**Technical Service
BULLETIN**

Title:
**REAR WIND DEFLECTOR
INSTALLATION NOTE**

Models:
'98 Land Cruiser

ACCESSORY
AX001-98

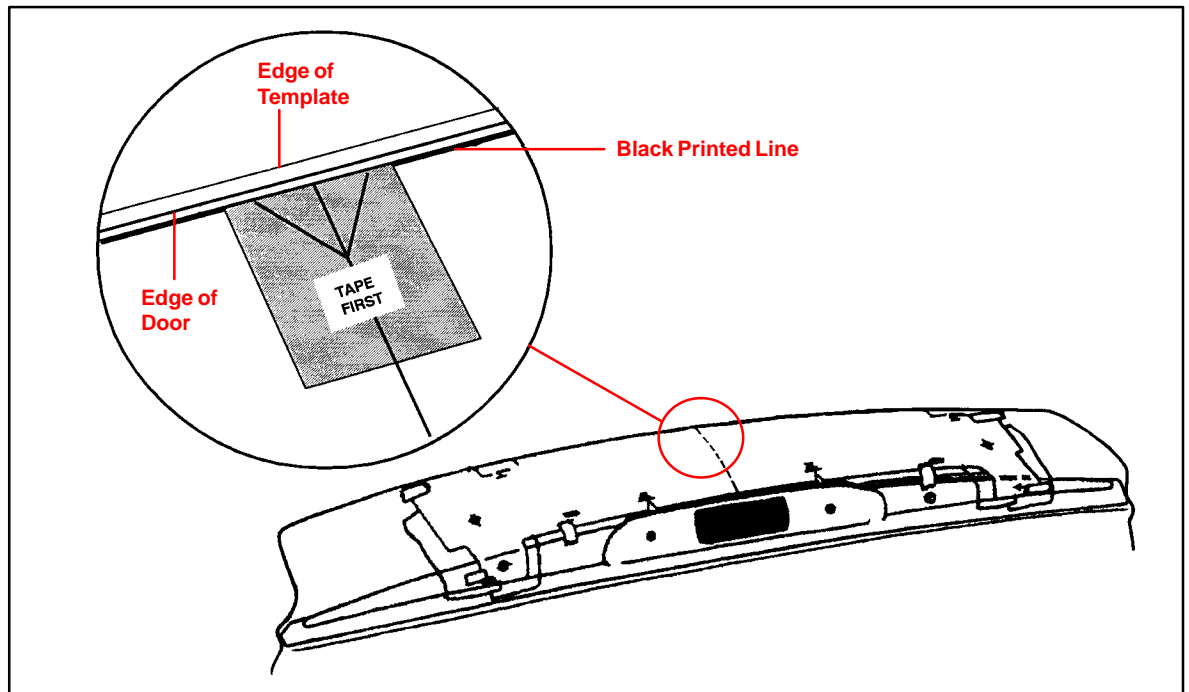
Introduction This bulletin is a correction to the installation instructions for the Land Cruiser Rear Wind Deflector, page 2, step 7 which states "Make sure the front edge of the Template is in contour with the front edge of the door."

Change to Procedure Page 2, step 7 of the installation instructions *should* state: "Make sure the black printed line on the template lines up with the front edge of the door."

NOTE:
Do not line up edge of plastic template to edge of door.
